ADDENDUM No. TWO

Project Name: Nature Center
White Clay Creek State Park

Contract No.: NAT25805-NATCTR
Date of Issue: Wednesday, May 20, 2026

LOWER FLOOR PLAN - HVAC

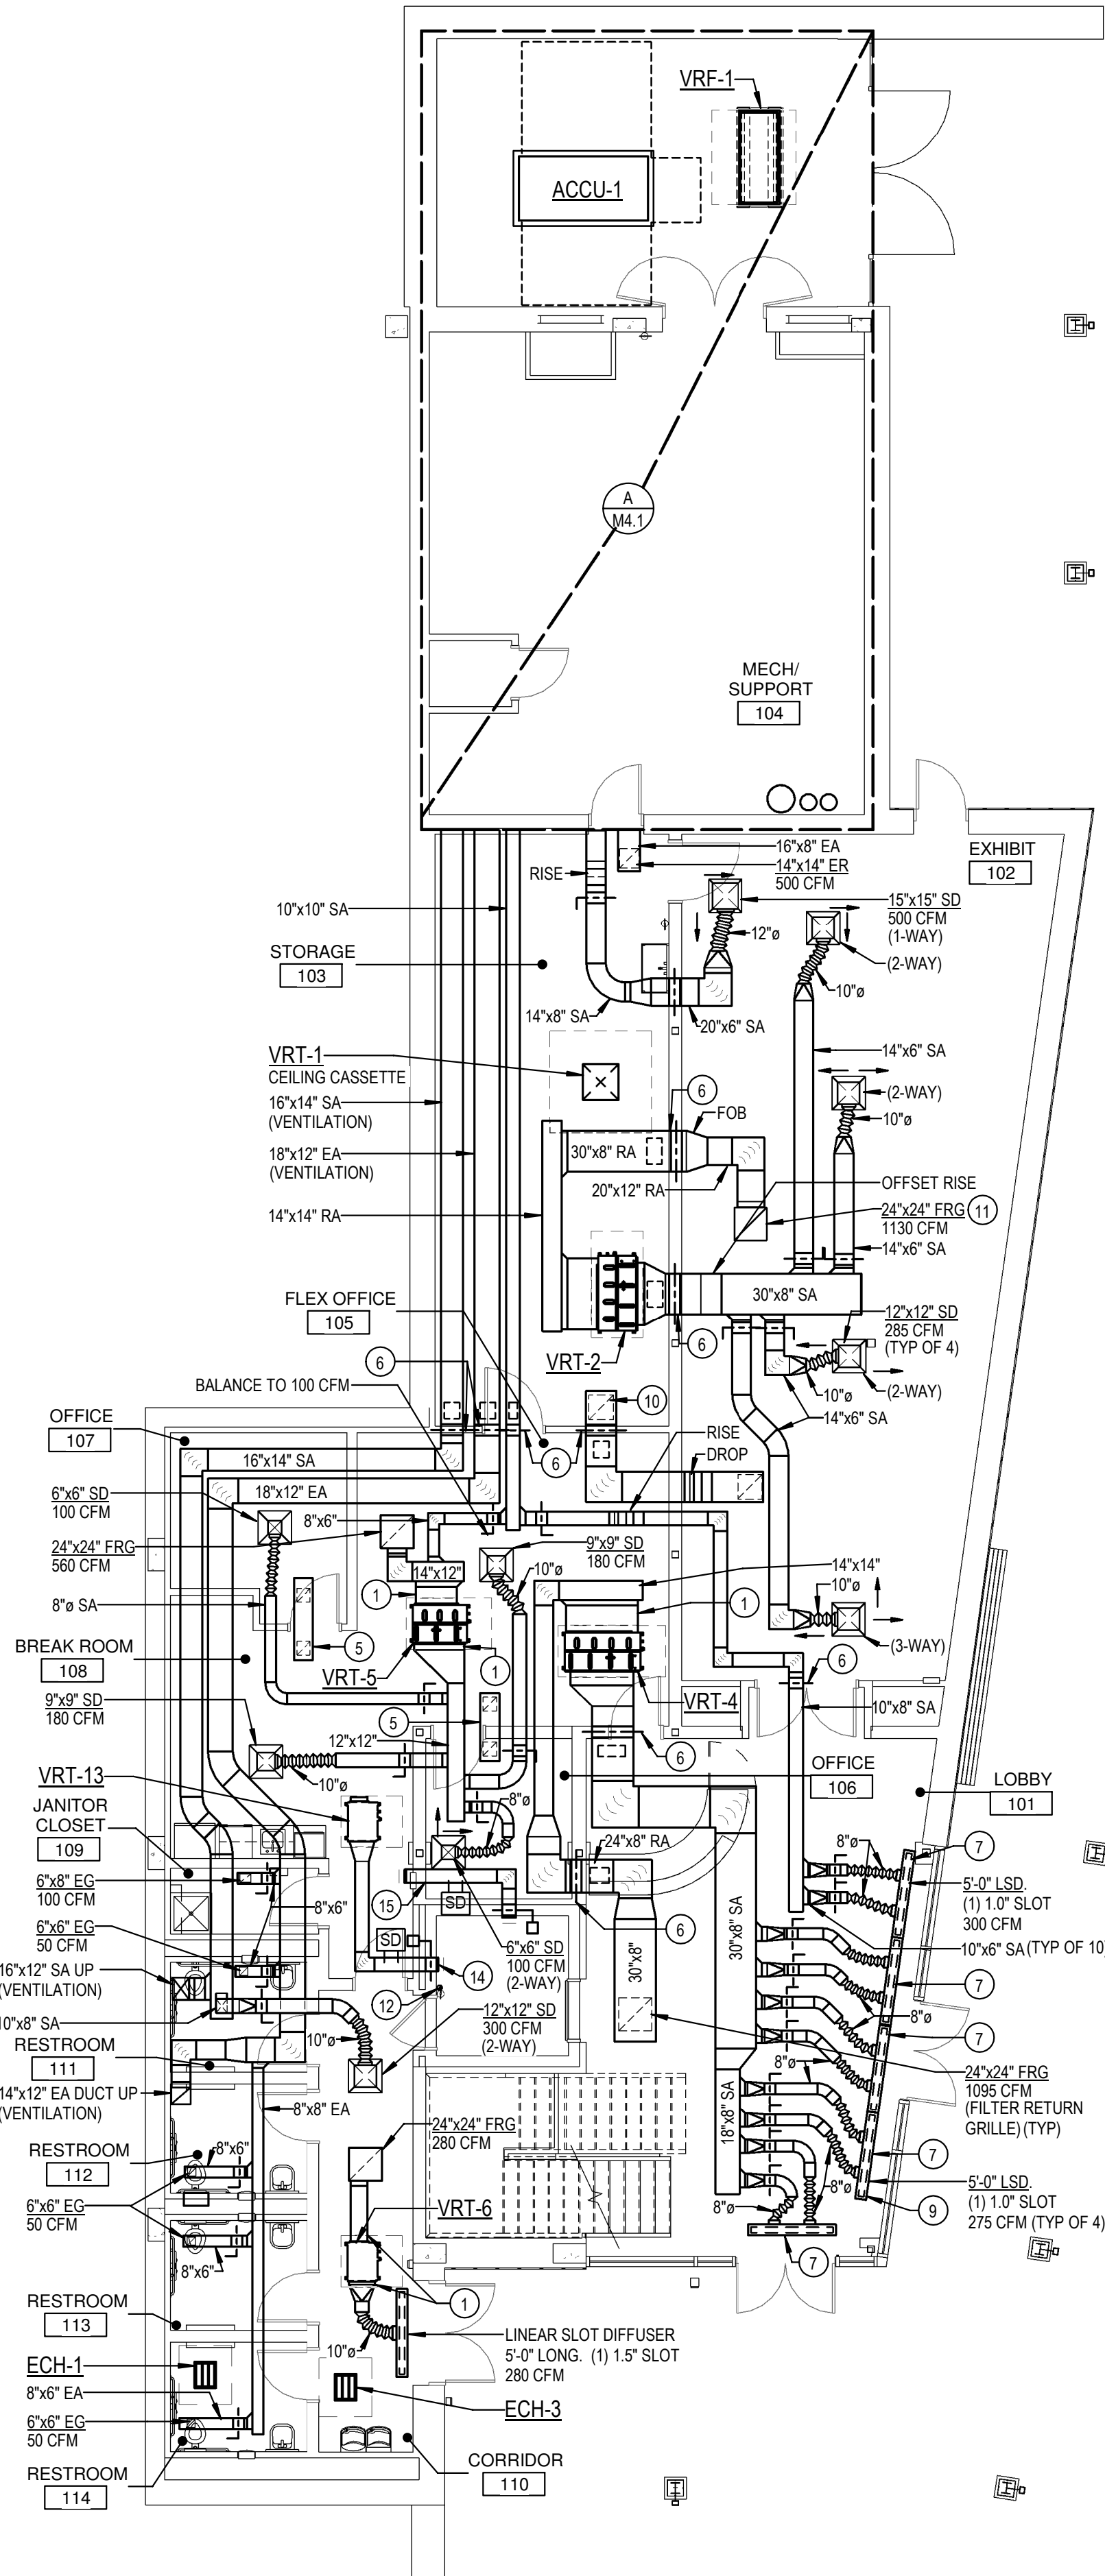
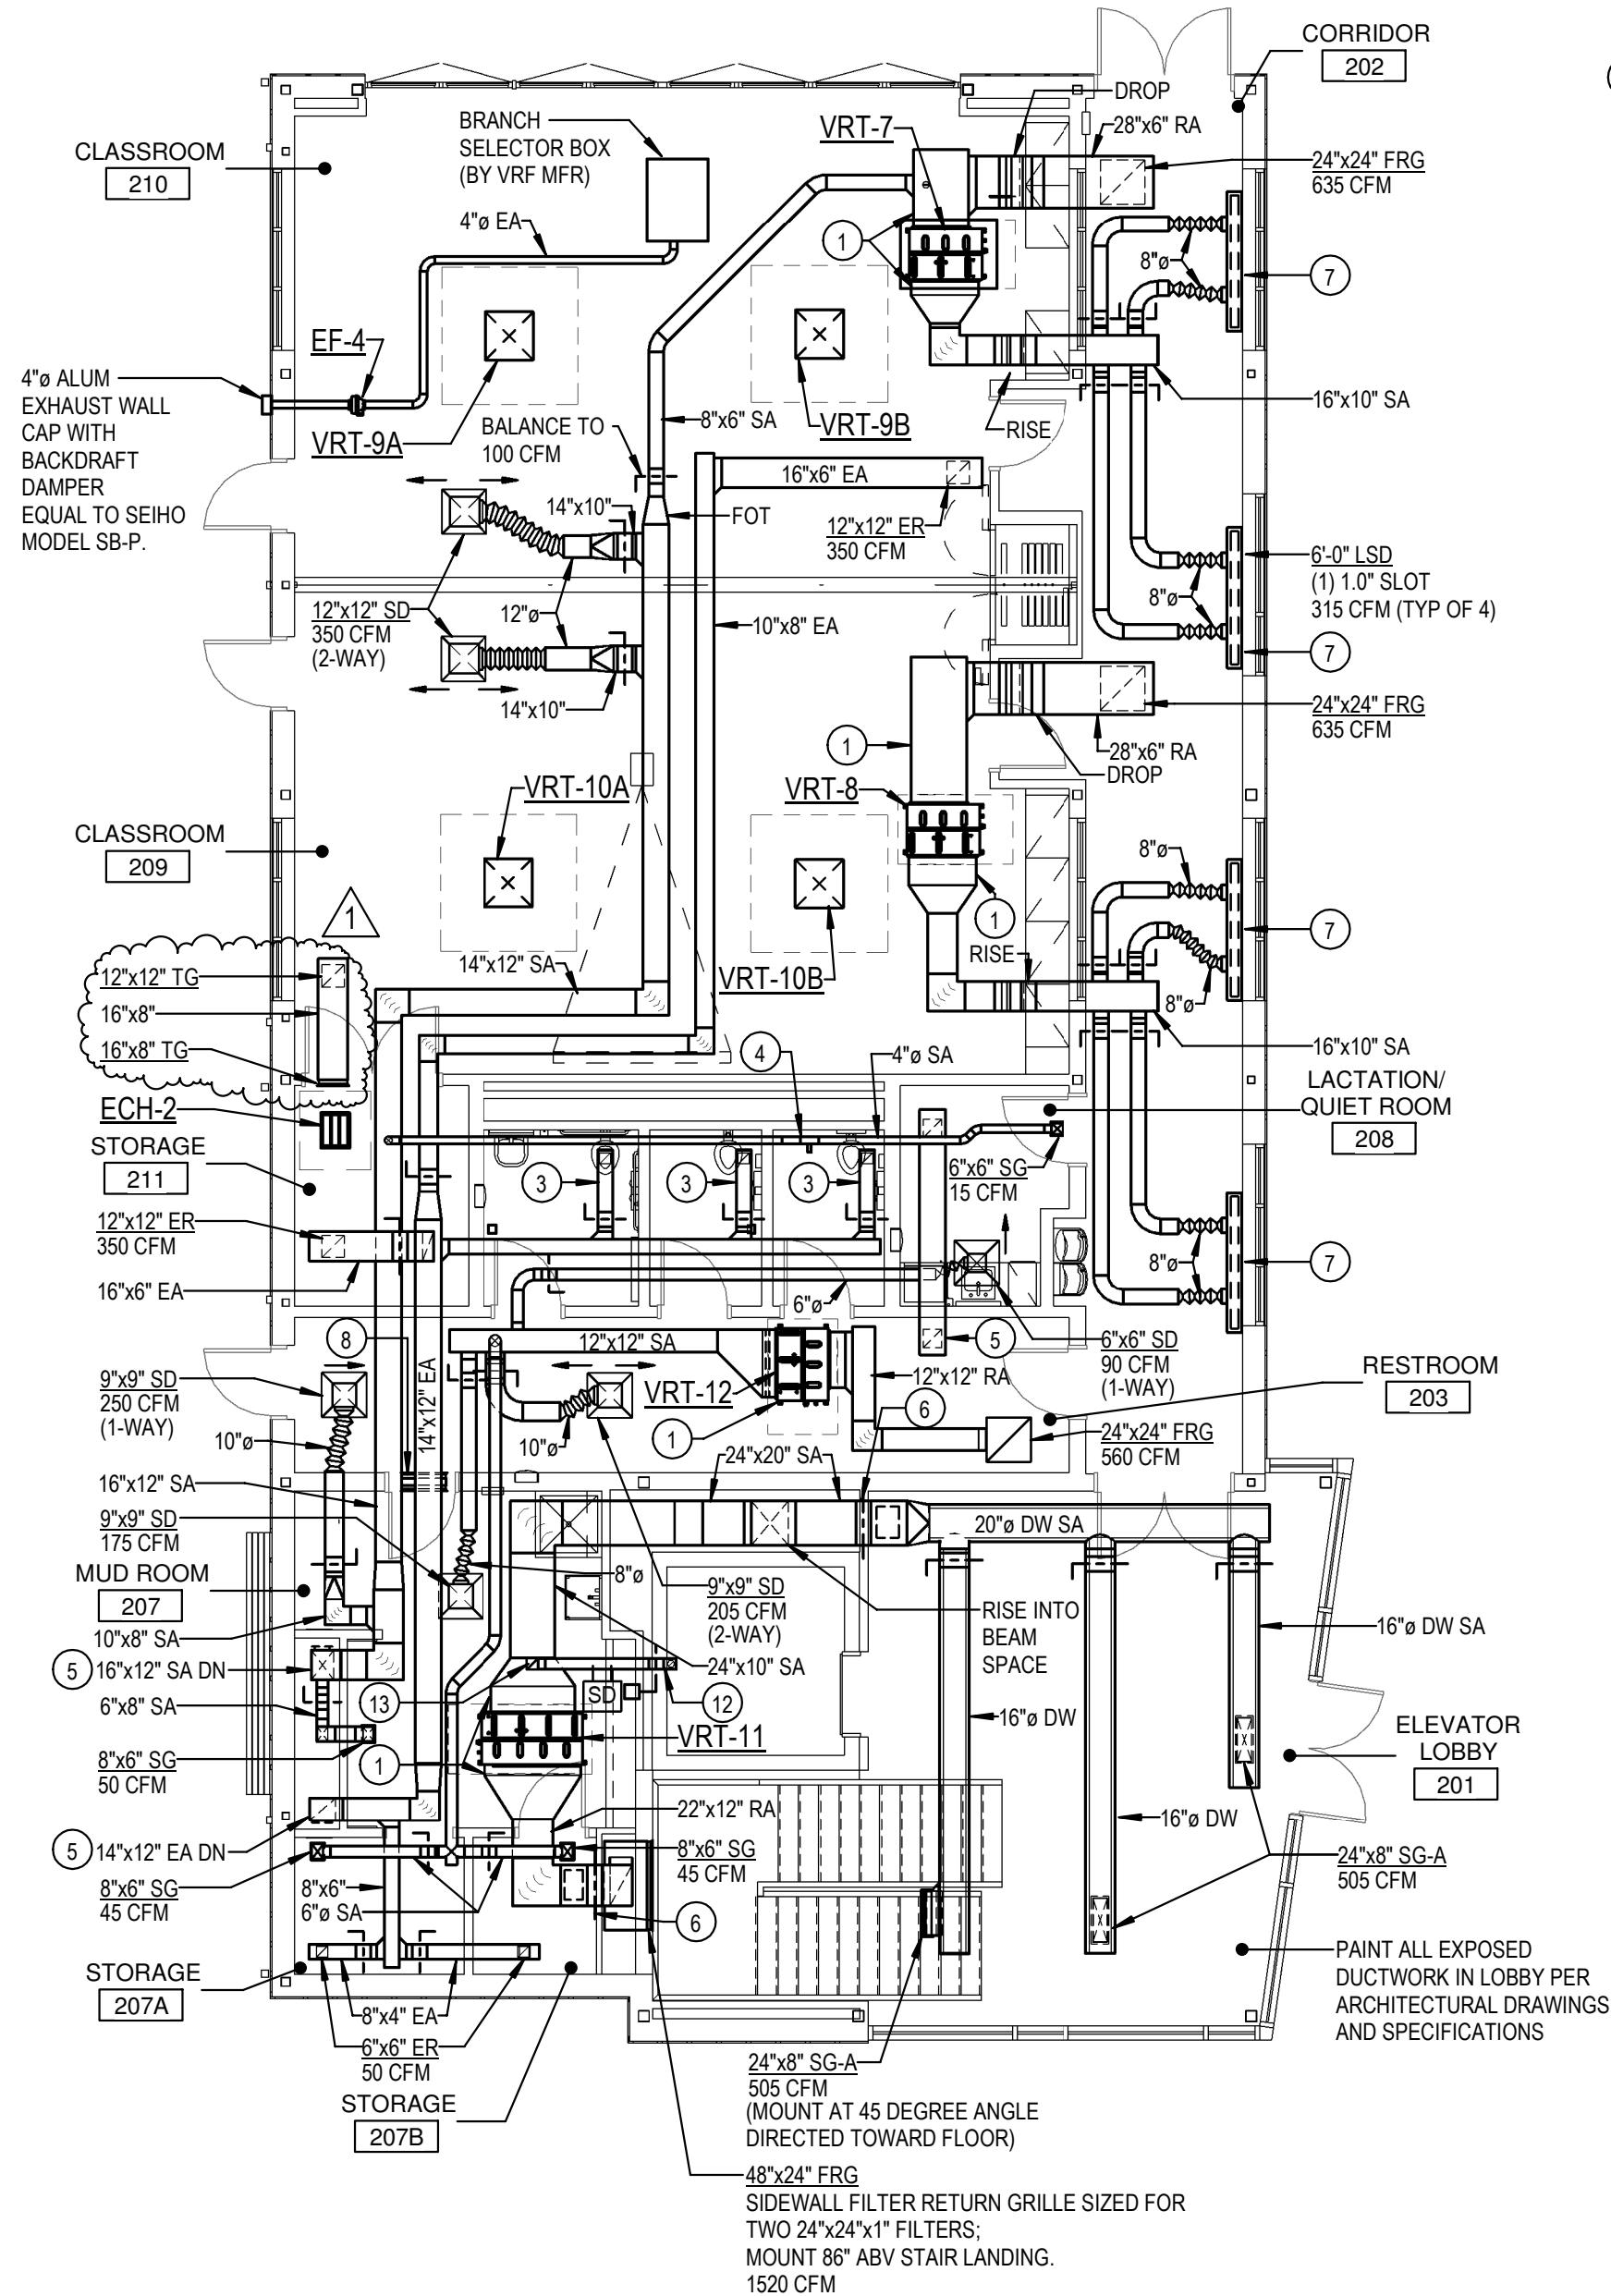
3. Sheet M1.1: FLOOR PLANS - HVAC
ADD: A transfer duct with associated ceiling and wall mounted transfer grilles was added to allow transfer air from Classroom 209 into Storage 211.
